TECHNICAL SPECIFICATION CHANGE REQUEST  
Susquehanna Steam Electric Station

Description of Change or Deviation Add six new containment isolation valves

Justification for Technical Specification Change (Provide Reference Specs., dwgs., or other documentation) DCP 89-3018A "Addition of New Containment Radiation Monitoring Sample Lines"

TECHNICAL ASSESSMENT: Addition of CRM Containment Penetrations

Figure 1

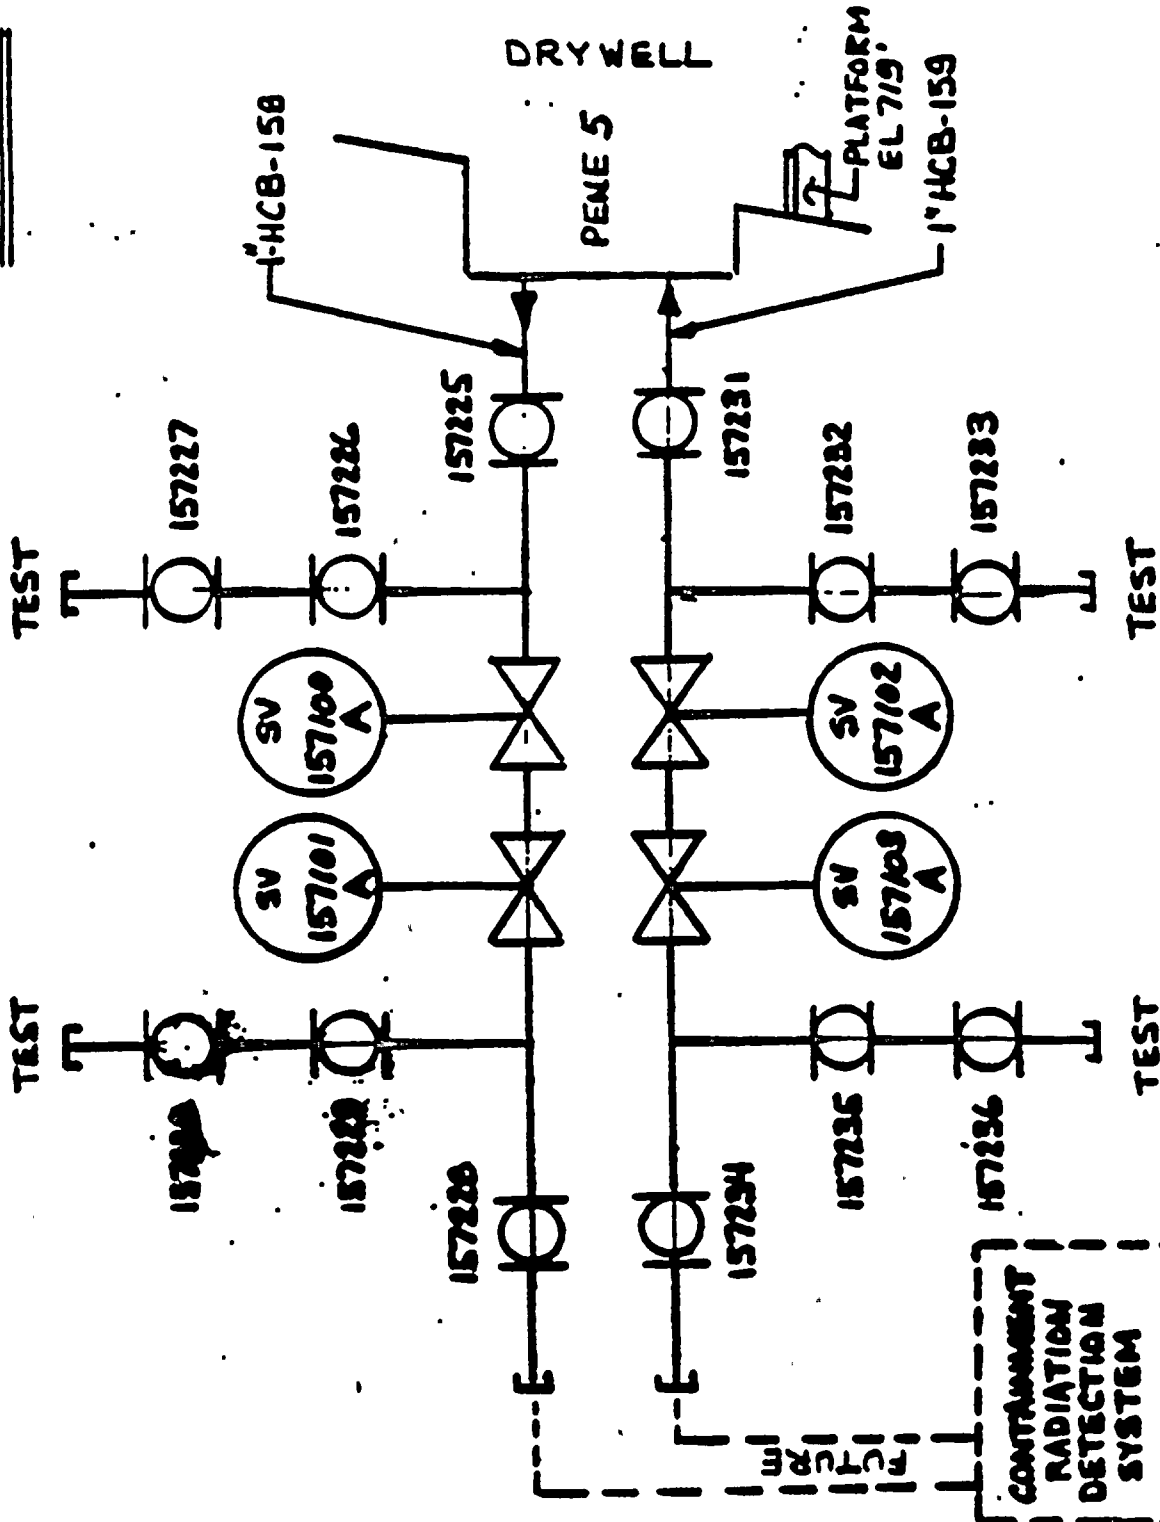
All new sample lines installed in this modification will have manual 1" full port valves provided on them to facilitate LLRT testing and isolation for system maintenance. The installation configuration is shown in attached Figures 1-3.
